APPENDIX I

Written Comments on the DEIS,
Community Board 5 and Manhattan Borough
President's Recommendations,
and Vornado Correspondence

15 Penn Plaza: CPC public hearing questions (5/26/2010)

15 Penn Plaza: Response to CPC Questions
(CPC Public Hearing: 5/26/2010)

PLAN VIEW OF PASSAGEWAY

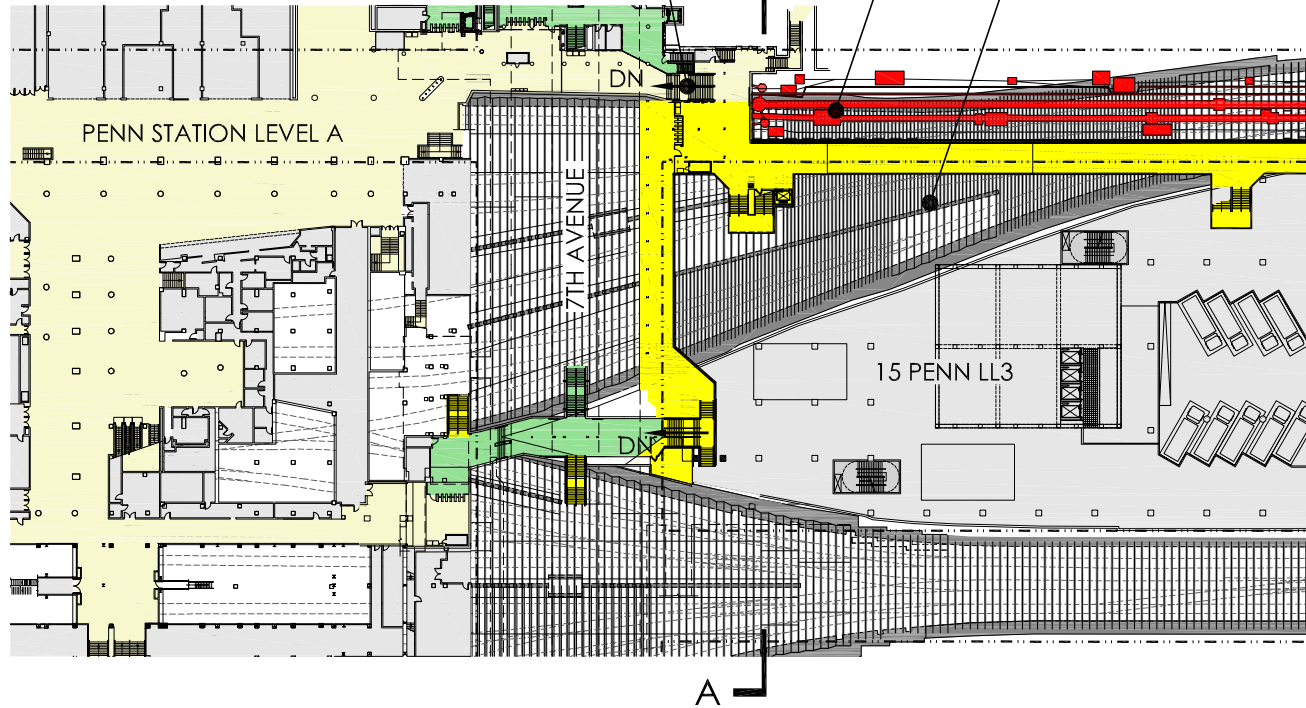
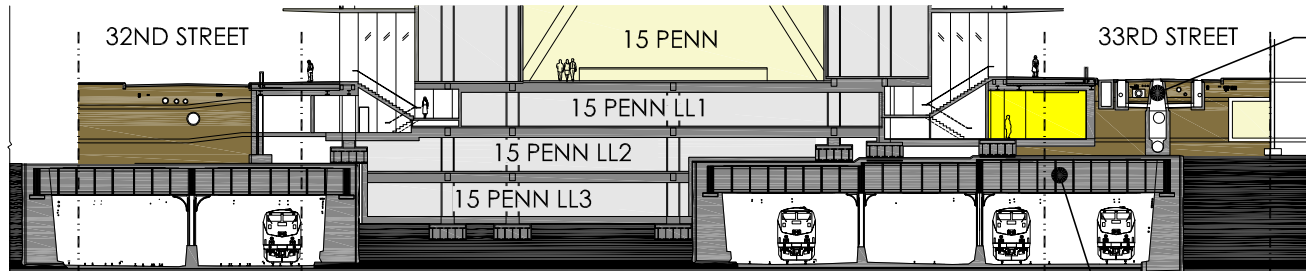
1. *Certain questions were raised regarding the dimensions and the location of the rebuilt Gimbels' passageway.*
 - Due to adjacent infrastructure constraints along its length, the dimensions of the passageway vary between the 15 Penn site and the Manhattan Mall site. Along the 15 Penn site, the width of the new passageway is 16 feet; on the Manhattan Mall site, the width varies between 14'8" and 16'8". The height of the passageway varies from just under 10 feet, at the lot line between 15 Penn and Manhattan Mall and at the highest point of the passageway ramp running along the 15 Penn site, to 14'8", at the 6th Avenue PATH area, and to 13' feet, at the entrance to the 7th Avenue subway. Attachment 1(a) to this memo provides fully dimensioned passageway plans.

- PASSAGEWAY CANNOT BE LOWERED DUE TO EXISTING TRAIN SHED STRUCTURE DIRECTLY BELOW PASSAGEWAY
- PASSAGEWAY CANNOT BE MOVED TO THE NORTH OF THE TRAIN SHED DUE TO MAJOR UTILITIES LOCATED BENEATH 33RD STREET

ATTACHMENT 4

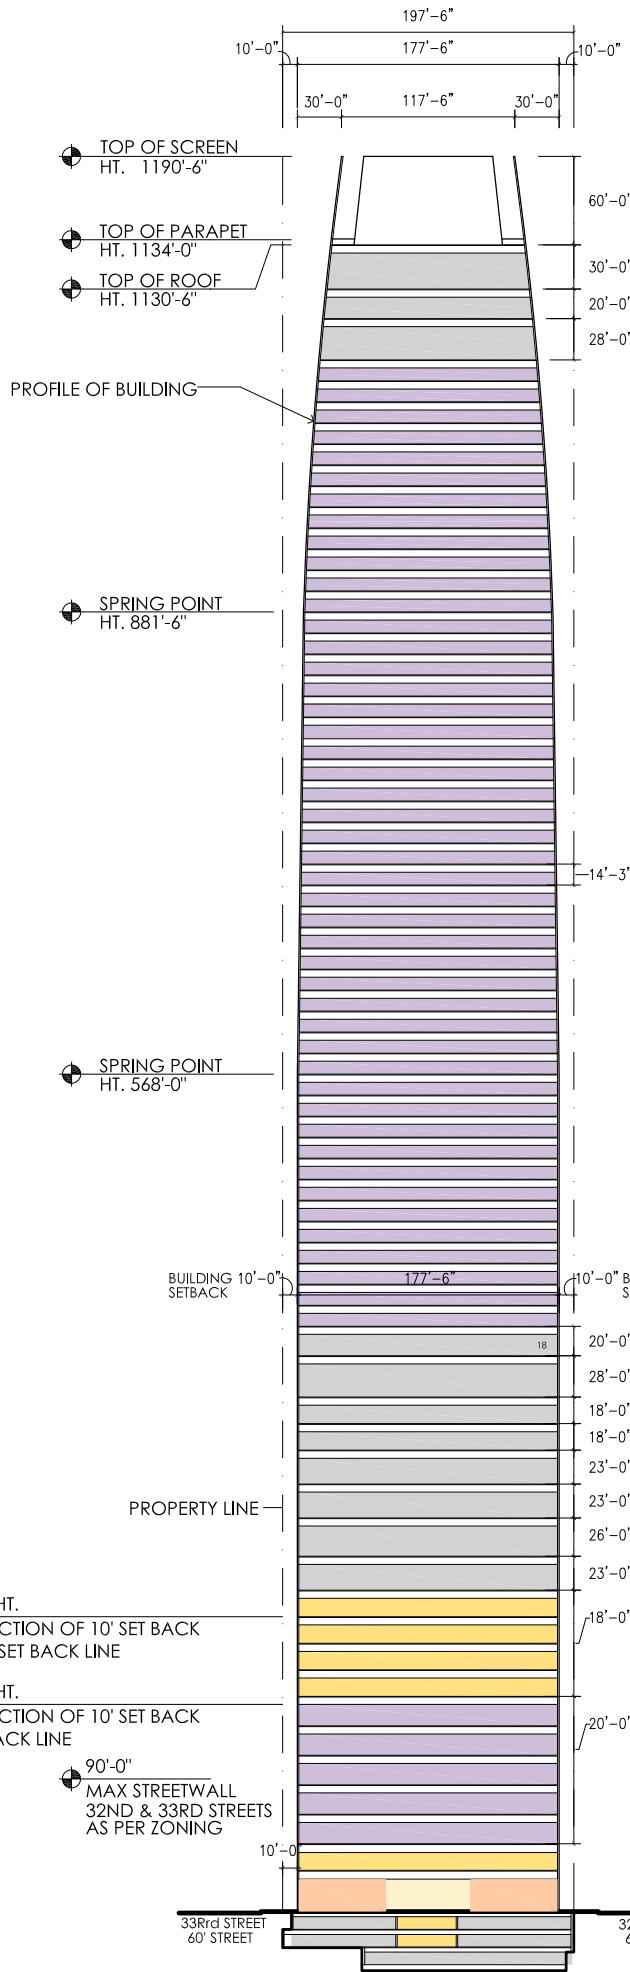
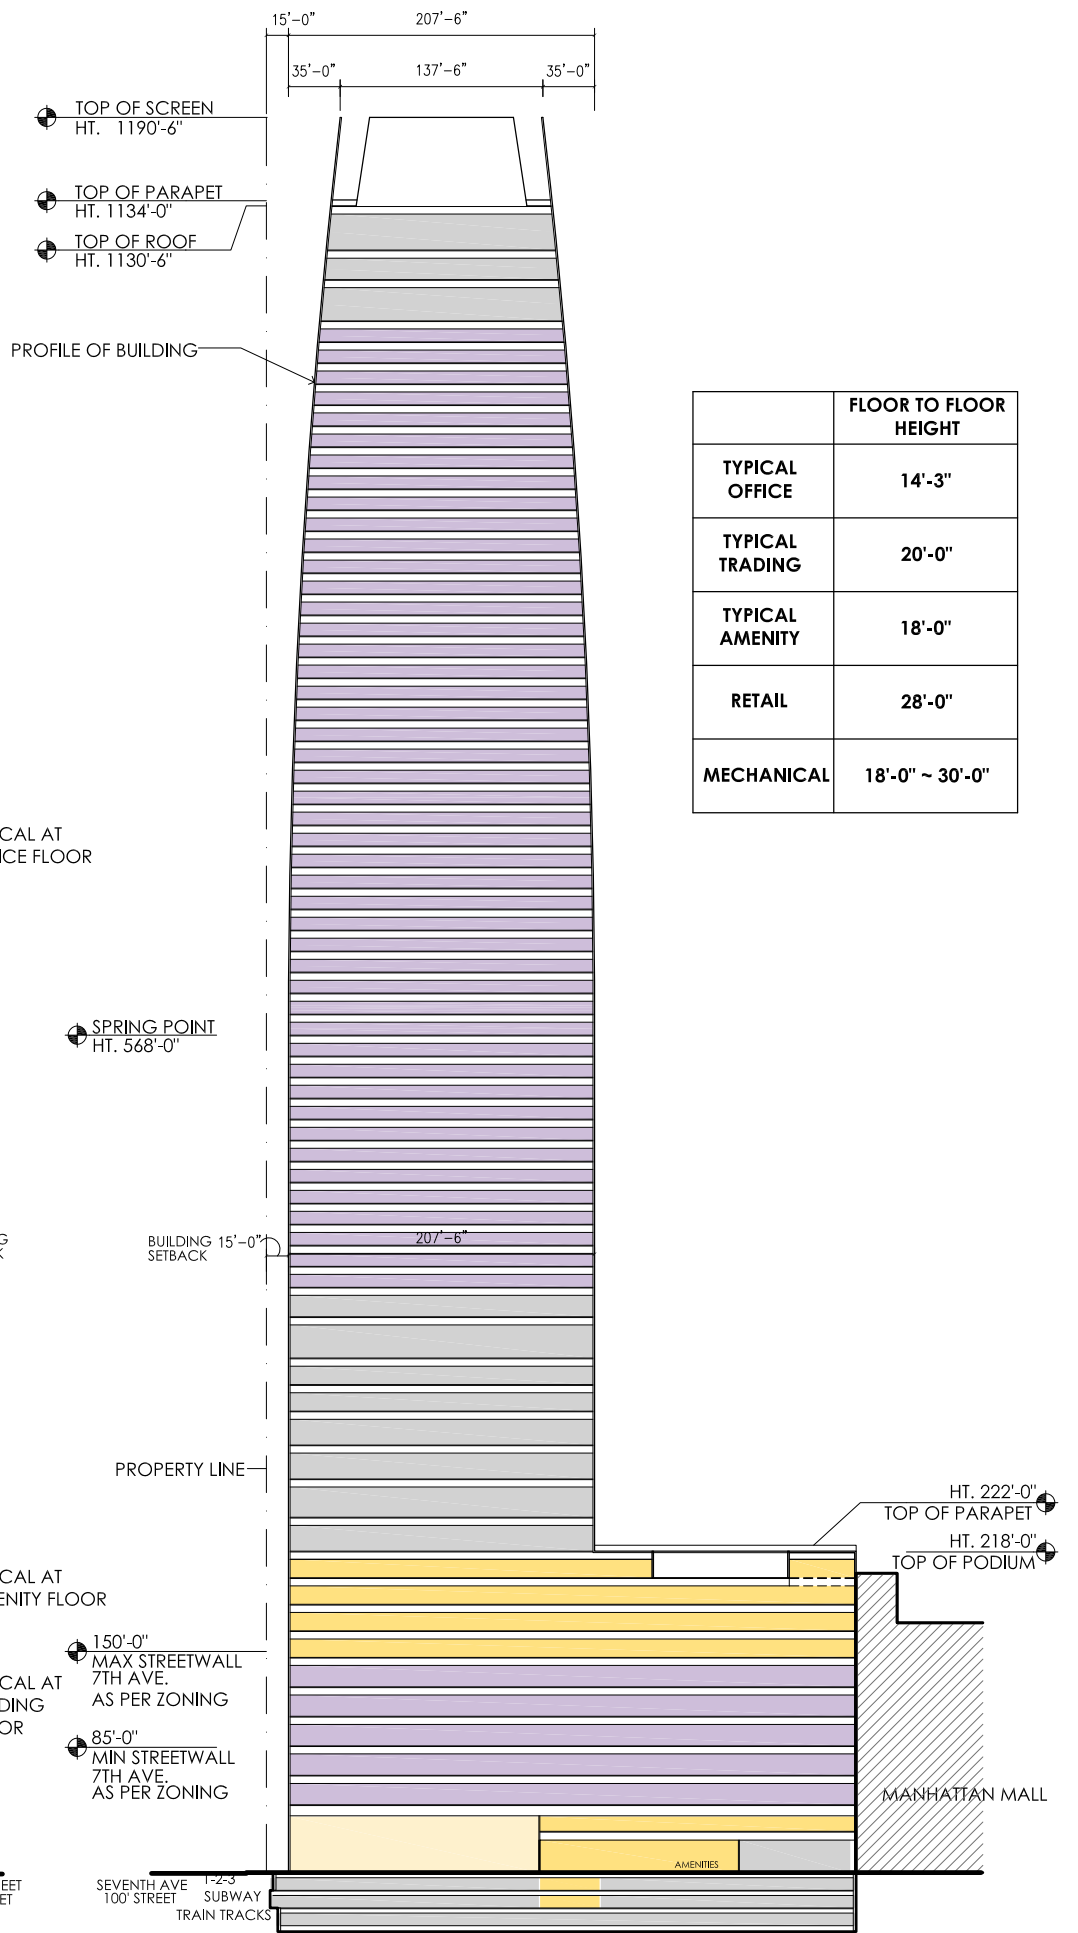
3. *The amount of mechanical space in the building seemed extensive, and a question was asked regarding how it compared to other financial service headquarters.*

- In answer to a specific question raised at the hearing, all mechanical equipment areas serving data and IT centers are included within this percentage.

ATTACHMENT 5a

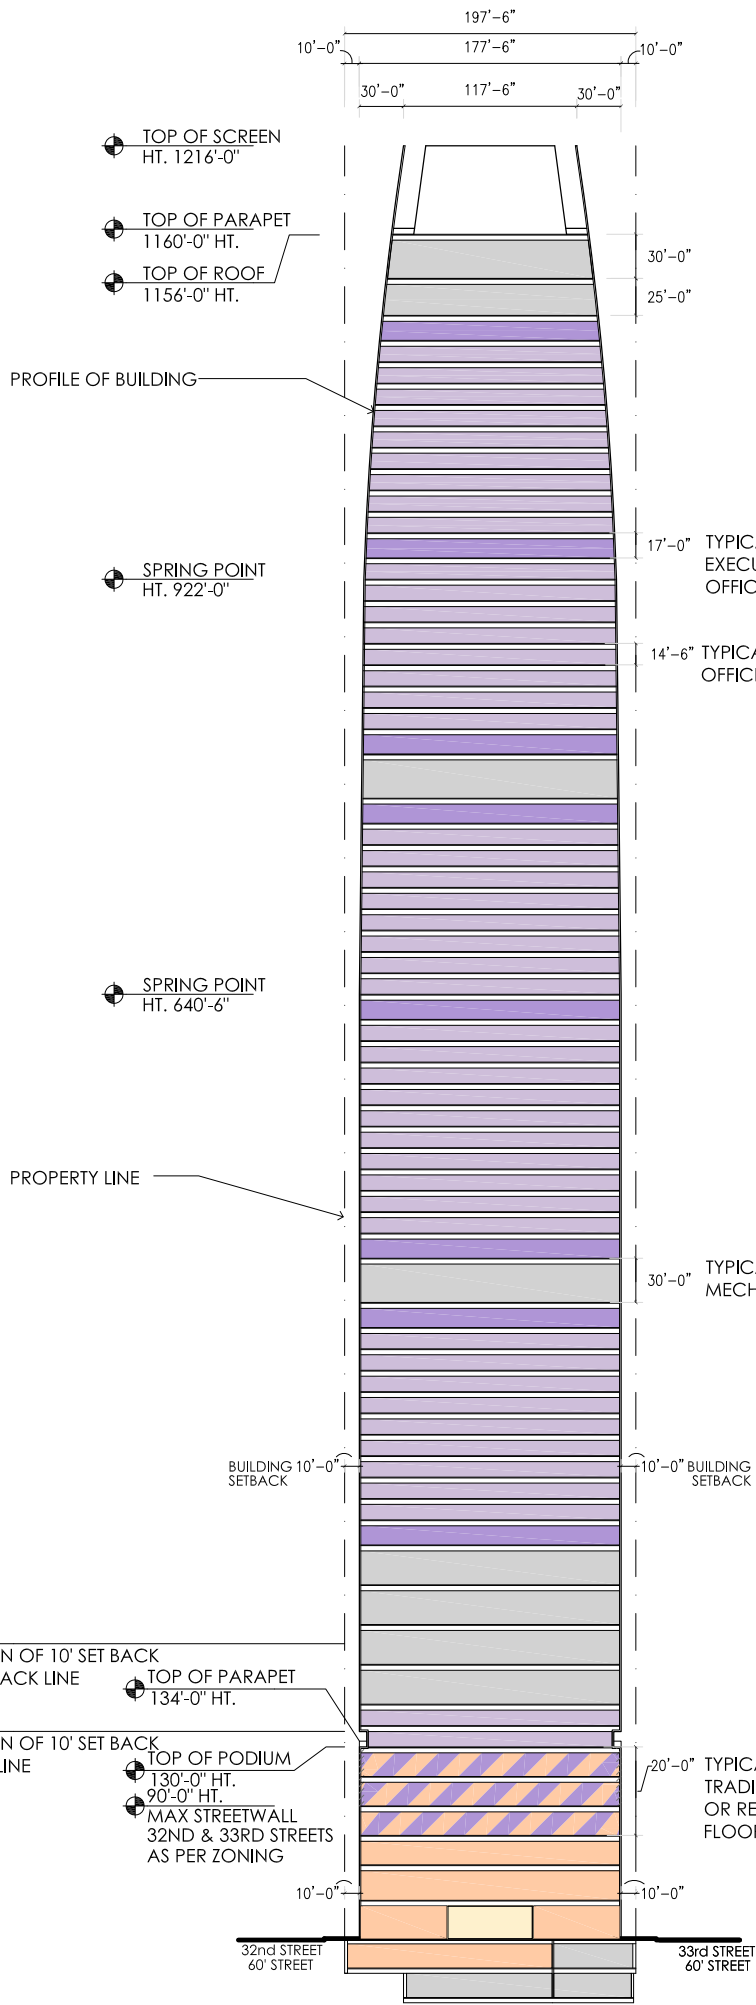
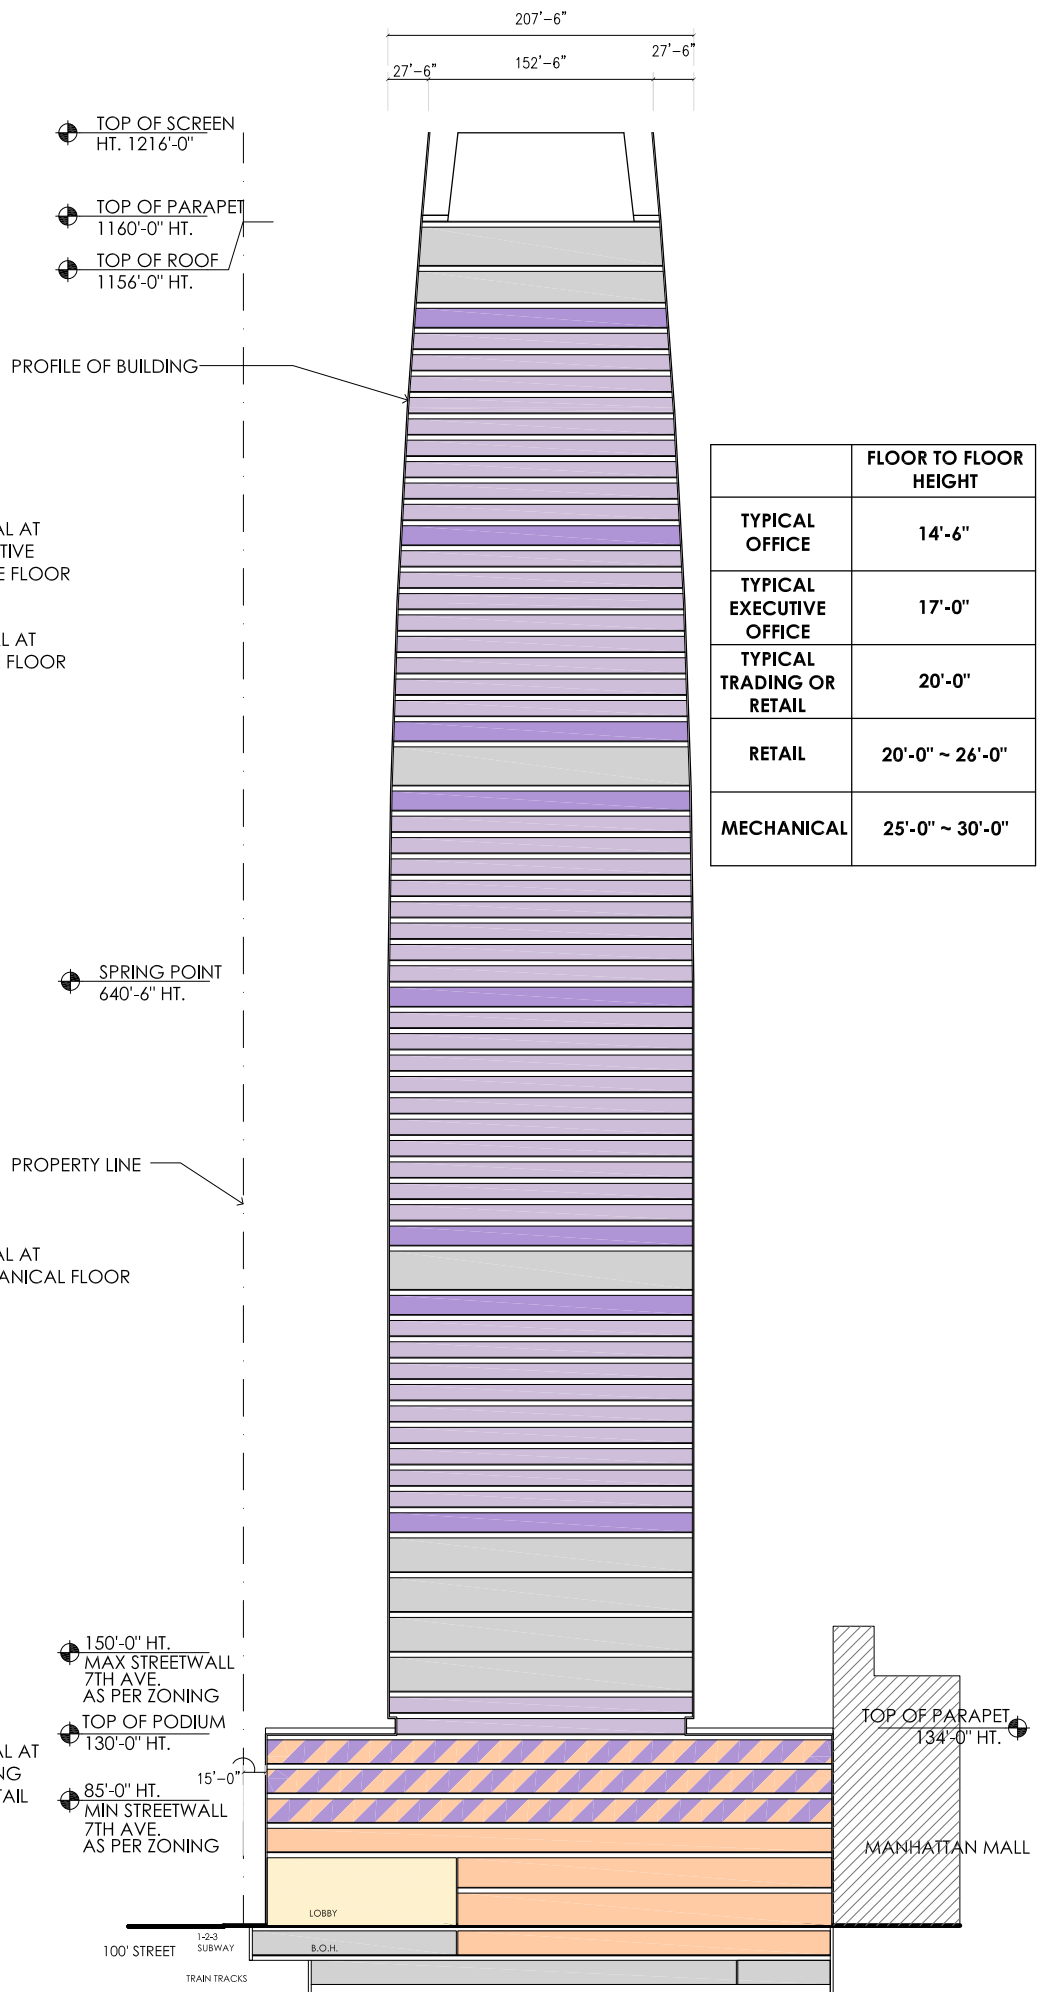
5. *A question was raised regarding floor-to-floor heights in both buildings.*
 - Attachment 5(a) shows the floor-to-floor heights at each level of the single-tenant building.
 - Attachment 5(b) shows the floor-to-floor heights at each level of the multi-tenant building.

FLOOR TO FLOOR HEIGHT
TYPICAL OFFICE	14'-3"
TYPICAL TRADING	20'-0"
TYPICAL AMENITY	18'-0"
RETAIL	28'-0"
MECHANICAL	18'-0" ~ 30'-0"
